Standardized Nuclear Unit
Power Plant System

July 8, 1983

SLNRC 83-0036 FILE: 0543
SUBJ: SNUPPS Technical Specifications

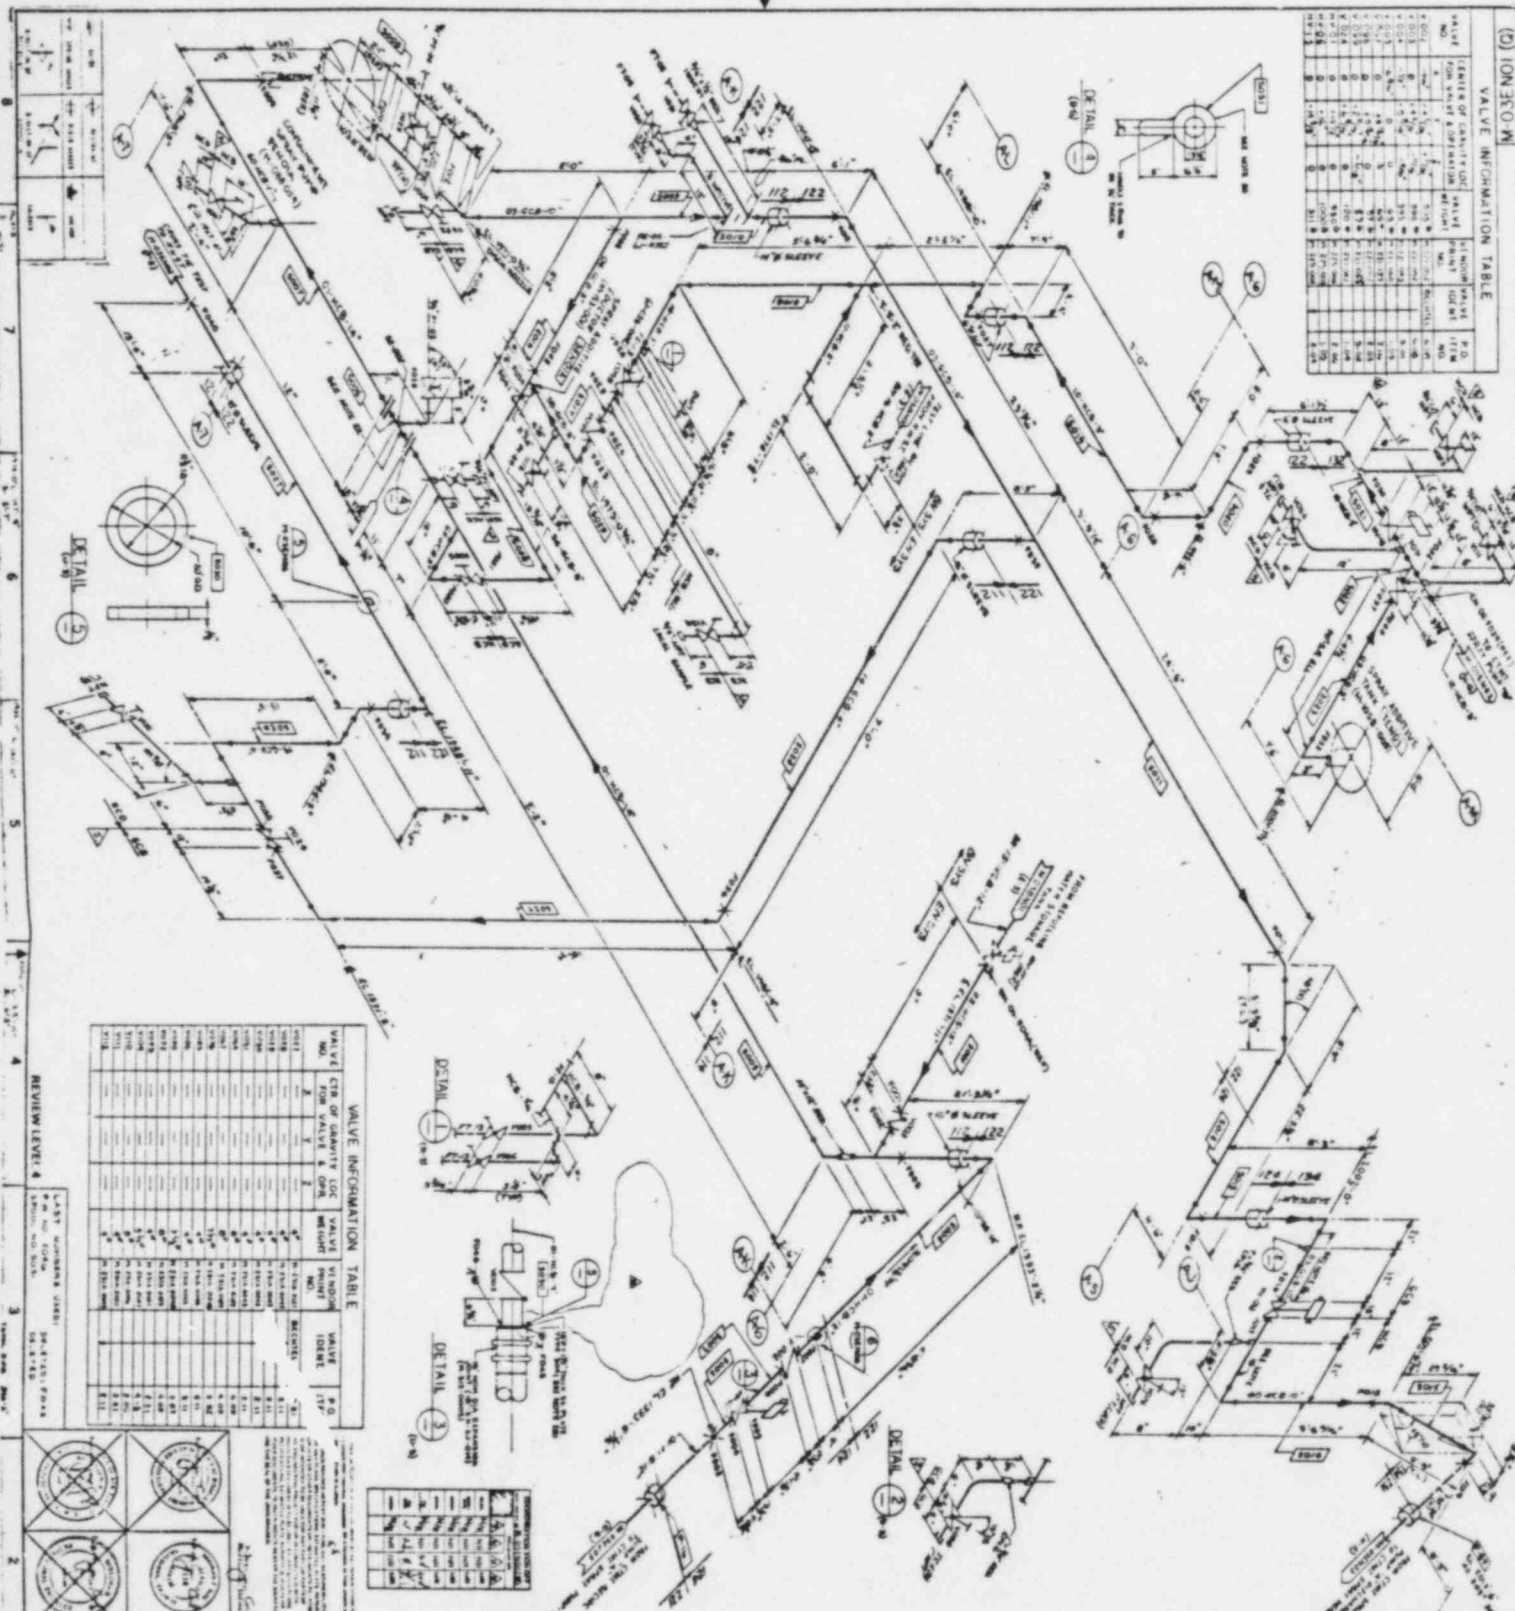
A new 4.6.2.2.d was added which will allow SNUPPS to prove the capability of injecting NaOH from the spray additive tank to the eductor without risking contamination of the RWST water with NaOH solution. See Bechtal drawings: M-02EN01, M-03EN01, and M-03EN02.

- 1) Each eductor flow rate is greater than or equal to 52 gpm using the RWST as the test source throttled to 17 psig at eductor inlet, and
- 2) The lines between the spray additive tank and the eductors are not blocked by verifying flow.

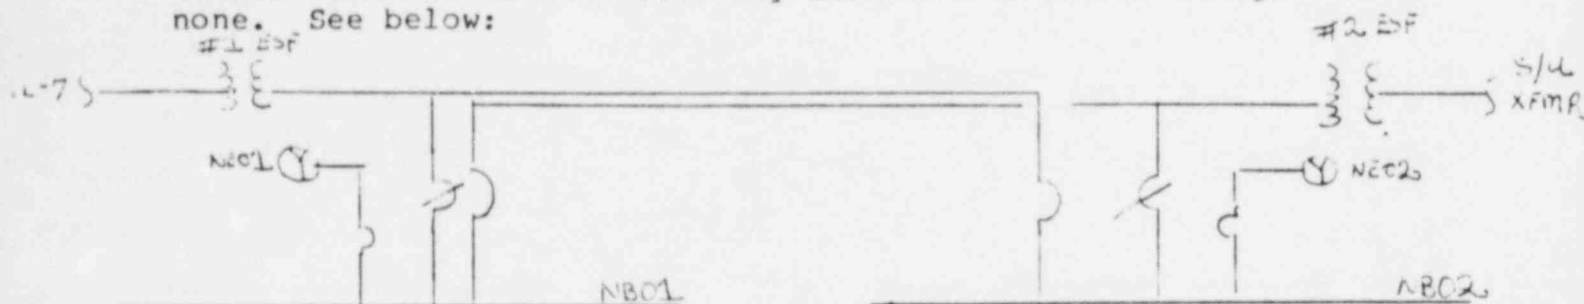
Two inverters may be disconnected from their D.C. bus for up to 24 hours, as necessary, for the purpose of performing an equalizing charge on their associated battery bank provided: (1) their vital busses are energized, and (2) the vital busses associated with the other battery bank are energized from their associated inverters and connected to their associated D.C. bus.

Specification: 3.8.3.1Justification:

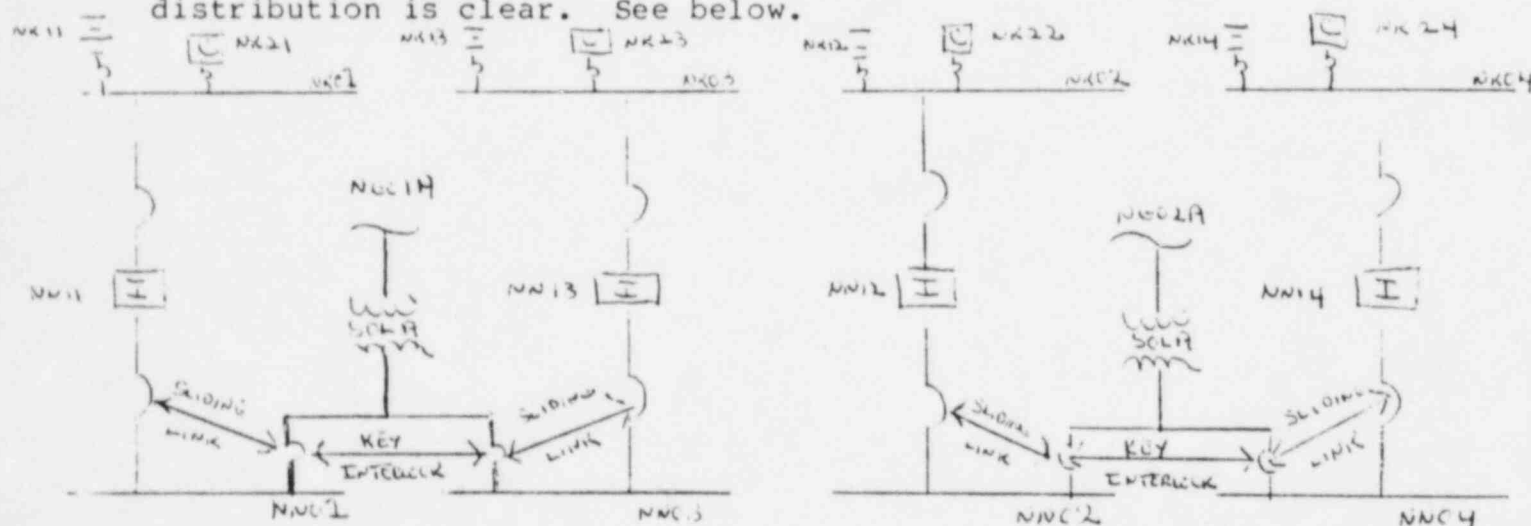
SNUPPS has no problem with the layout of the LCO, but a reference to tie breakers is not necessary because the SNUPPS design has none. See below:

Also, SNUPPS will accept 2 inverters in the note vice the one submitted, but SNUPPS wants to ensure our electrical distribution is clear. See below.

Thus, SNUPPS can have, at the most in this system, 2 inverters out of service and still have the respective NN busses energized.

Technical Specification: 3.8.3.2 Action Statement

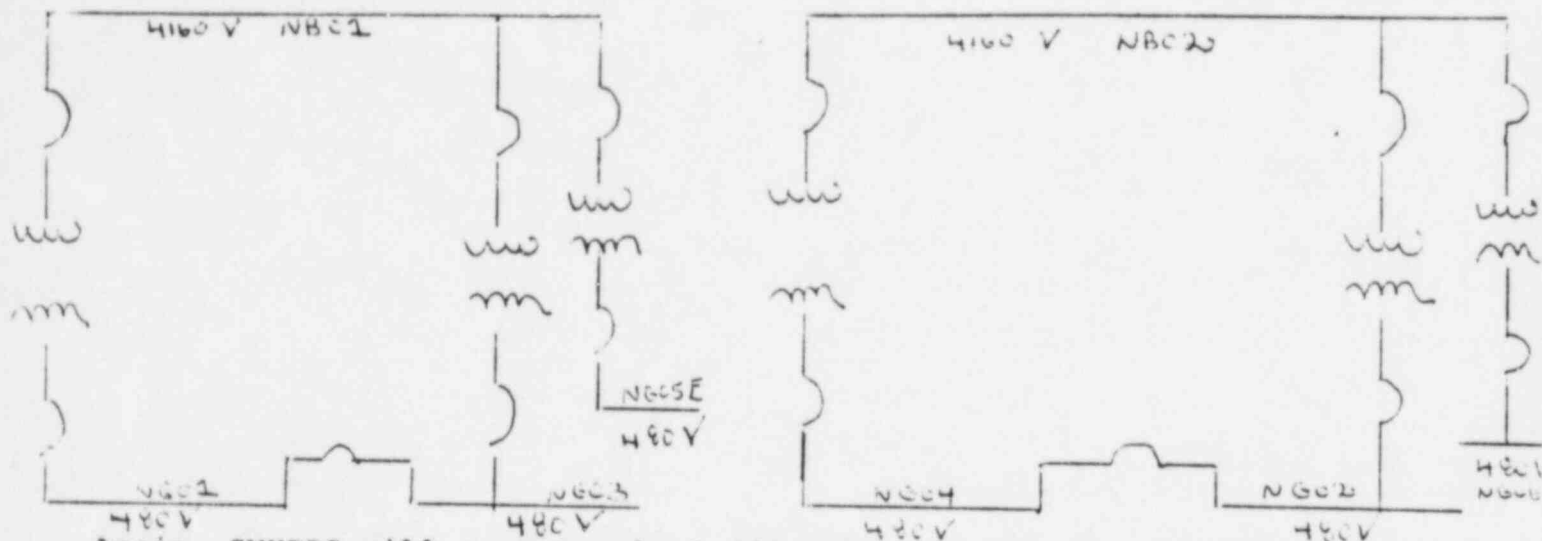
(a) Overpressure protection is provided and covered in Tech. Spec. 3.4.9.3 and establishment of containment integrity should allow for the ability to perform core alterations or movement of irradiated fuel.

(b) The change to the action statement is proposed to allow use of a backup power supply which is available, reliable and compatible with the system it would serve as backup. The independence and redundancy is still maintained with respect to the other load group. The ability to utilize the A.C. transformer is commensurate with FSAR section 8.3.1.1.5, Reg. Guide 1.32, and IEEE Standard 308-1974. This revision allows time to repair the inoperable inverter and allows the plant to select the optimum time to place the inverter back in service. This selection would give consideration to the impact of the dead bus transfer.
